Superfund Record of Decision:

Goose Farm, NJ

Record of Decision
Remedial Alternative Selection

Summary of Remedial Alternative Selection

FIGURE 3
 GOOSE FARM
 PLUMSTED TOWNSHIP, NEW JERSEY
 RECOMMENDED ALTERNATIVE 4

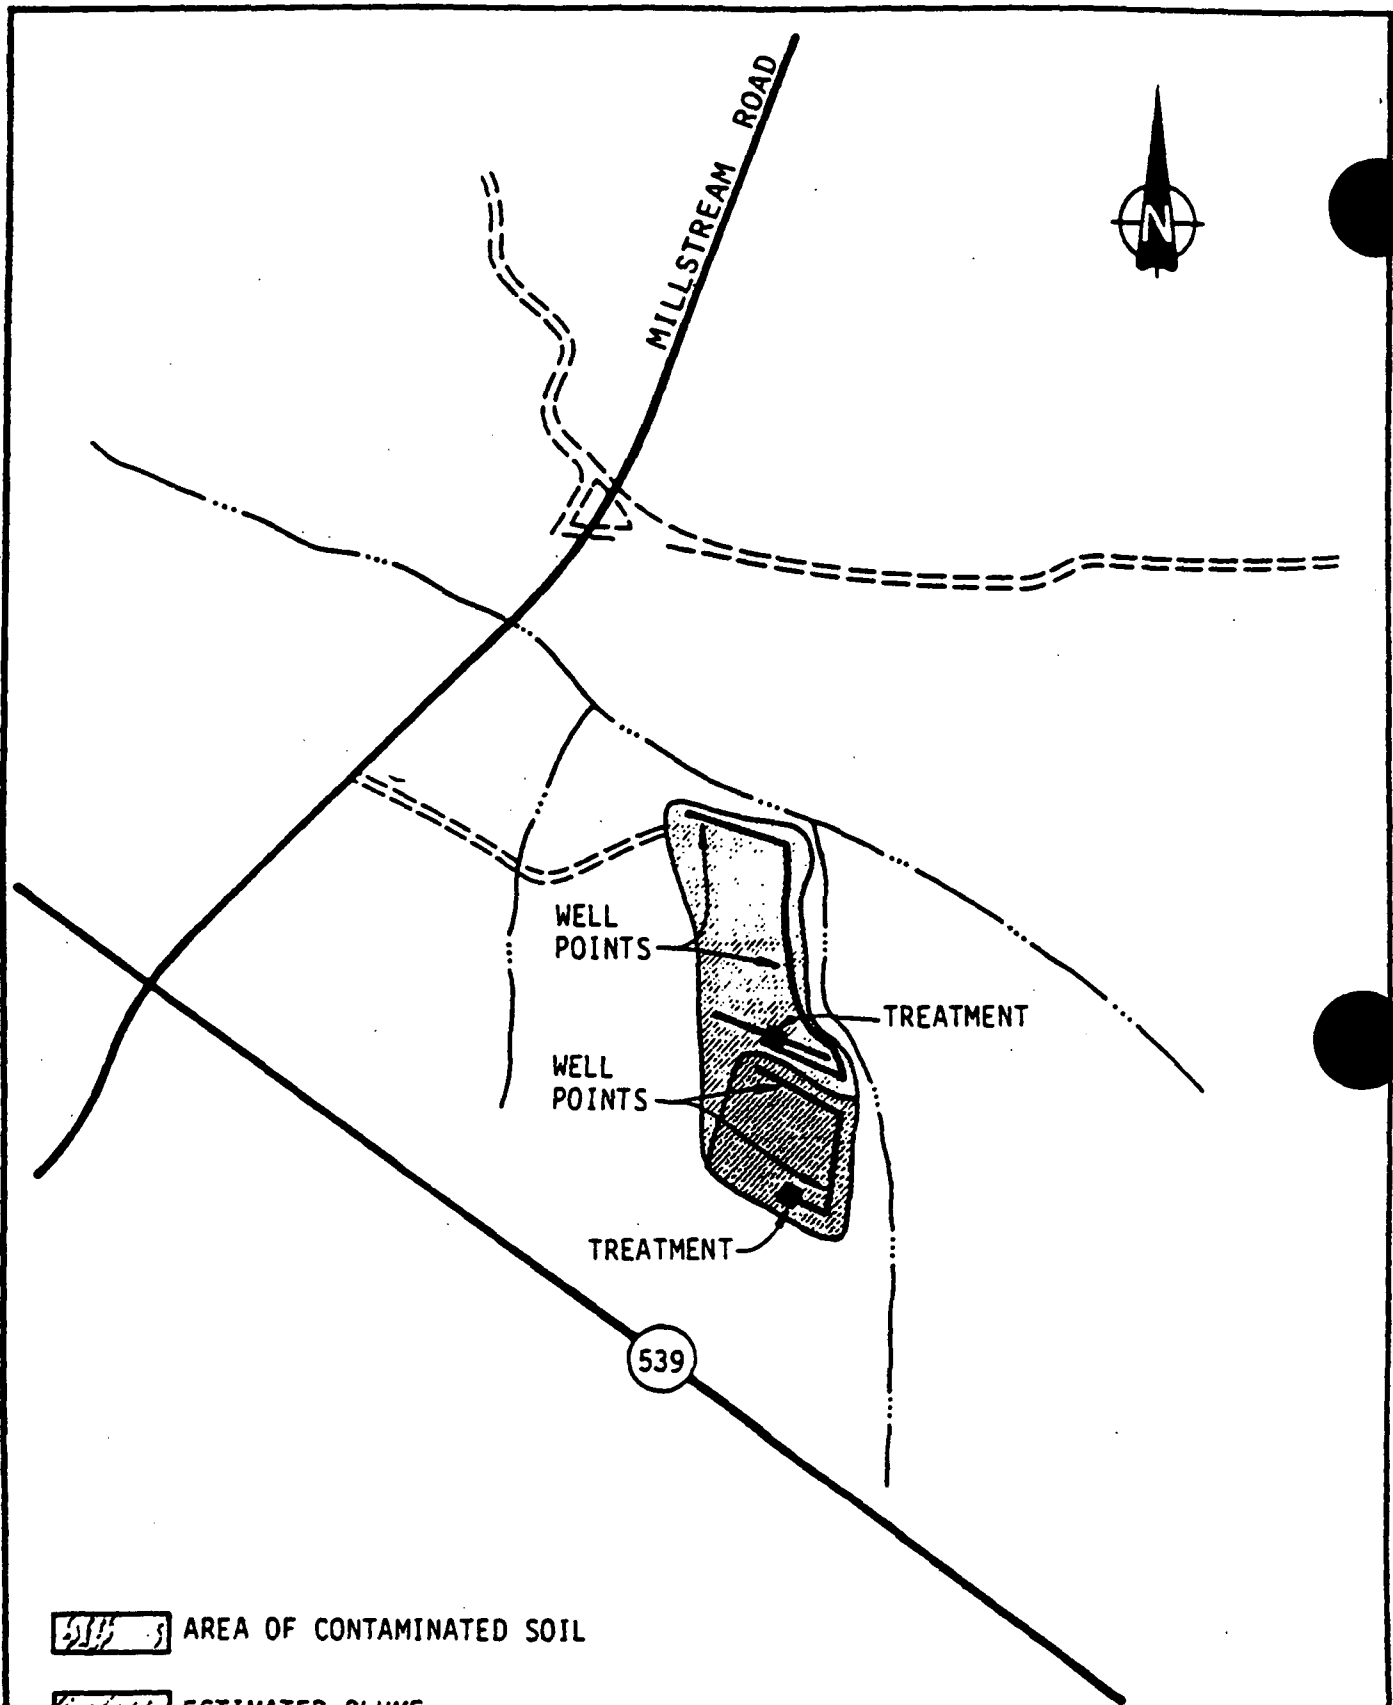
of a remedial alternative which seems incapable of meeting any reasonable set of performance objectives and certainly not in the time frame projected in the RI/FS. The remedial plan optimistically envisions an 18-month period of soil flushing and plume recovery and treatment, after which presumably the aquifer and site would be sufficiently renovated. As will be demonstrated subsequently, it is our belief that this plan is seriously flawed for all but the most relaxed of performance standards. The flaw lies in the fact that the consultants have assumed that the soil and groundwater contaminants will either be flushed relatively rapidly from the system, within the 18-month period, or will be permanently bound up in the soils. This is an unrealistic and, in fact, a dangerous assumption. In reality, the Goose Farm soils and groundwater contain a complex suite of organic and inorganic contaminants whose retardation factors and, consequently, times of flushing span the mobility spectrum. By underestimating the complexity of the source, TRIA has recommended a remedial plan the success of which hinges on relatively rapid soil flushing and aquifer renovation. As the subsequent calculations will show, flushing of this aquifer system will not be rapid. In fact, the calculations indicate that flushing will take not months but many years, even decades.

As stated earlier, the technical merits of TRIA's Alternative #4 seem questionable. Its success hinges on what can best be considered the optimistic belief that the Goose Farm contaminants will fall into one of two categories: those which will be rapidly flushed from the soils, and those which will remain permanently bound to the soil matrix. The plan envisions an 18-month period of soil flushing and plume treatment, after which presumably the highly mobile contaminants will have been flushed from the soil and the aquifer and the remaining contaminants will remain bound to the aquifer skeleton.

Although the effectiveness of this option hinges on the rates of contaminant flushing and aquifer remediation, the RI/FS does not contain even preliminary estimates of these mechanisms. The sole reference to flushing times mentions achieving a ten-pore volume exchange of groundwater. The RI made no effort to measure the aquifer's natural organic content from which estimates of organic contaminant mobility can be drawn. TRIA has apparently simply guessed at the amount of flushing required to remove contaminants. As the succeeding evaluation will indicate, it appears that their unsupported estimate of flushing times is seriously in error. As a result, the aquifer remediation and soil flushing project would not be completed in the 18 months contended by TRIA. Rather, in all likelihood, it would be forced to operate for many years, even decades, before adequately remediating the aquifer and the soil contamination.

The TRIA groundwater recovery system is proposed to consist of a vacuum wellpoint system as indicated in Figure V-1. The vacuum wellpoints are to be aligned along the eastern and northern boundaries of the plume adjacent to the creeks into which the plume discharges. Because of the proximity to the creeks, induced infiltration of stream water into the groundwater recovery system will make up a significant portion of that system's flow. This induced surface water infiltration could potentially account for between 30 and 70 percent of the total flow of the wellpoint system. It will depend upon the system's geometry and flow rates, aquifer properties, and stream bed and flow characteristics. Obviously, inducing this significant in-flow of uncontaminated water into the system has several negative side effects. First, it would necessitate increasing the hydraulic capacity of both the well point system and the groundwater treatment plant. More important, however, it will serve to throw the remedial project out of hydrologic balance. Alternative #4 is intended to operate as an essentially "closed-loop" system. Recovered contaminated groundwater is intended to be treated and returned to the aquifer near the northern end of the disposal pit (see Figure V-1 of the Feasibility Study). The aquifer within the plume has a finite capacity to store and conduct groundwater. The continuous addition of surface water into the system will eventually overwhelm the aquifer, potentially causing one or more of several problems. First, the groundwater could rise to excessive levels in the recharge area, possibly reaching the ground surface, causing obvious problems. Second, the potentiometric highs caused by the recharge system could serve to expand the plume laterally beyond its present boundaries.

The TRIA-recommended remedial option envisions accelerated soil flushing as a means to enhance the migration of leachable constituents to the groundwater recovery system. However, the means proposed to achieve this soil flushing will be at best partially effective. It is proposed that a wellpoint system consisting of 80 wellpoints be utilized to inject water back into the contaminated soil zone in the vicinity of the disposal pits. A sketch of the proposed system is presented in Figure V-1 of the feasibility study. A wellpoint system of this type will effectively flush only those soils in its immediate vicinity. Such a recharging wellpoint system will create a potentiometric ridge along its alignment and accelerate flushing only within the confines of the potentiometric ridge and the underlying saturated zone. Contaminants in the unsaturated zone more than a few tens of feet from the recharge system will likely be completely unaffected. Even contaminants in the unsaturated zone in the immediate vicinity of the wellpoint recharge system may be unaffected depending upon the resultant height of the potentiometric ridge. The TRIA RI/FS provides no quantification of the impact of the proposed soil flushing system upon the groundwater table or with regard to its effectiveness. Clearly this is another example of where a computer model could have been a great asset to the feasibility study process. With the computer model, the effectiveness of various soil flushing systems could be quantitatively evaluated.

5. While it is true that contaminant partitioning between ground water and the aquifer skeleton can occur, more than sufficient data exists to establish beyond question that true soil contamination and ground water contamination exist.
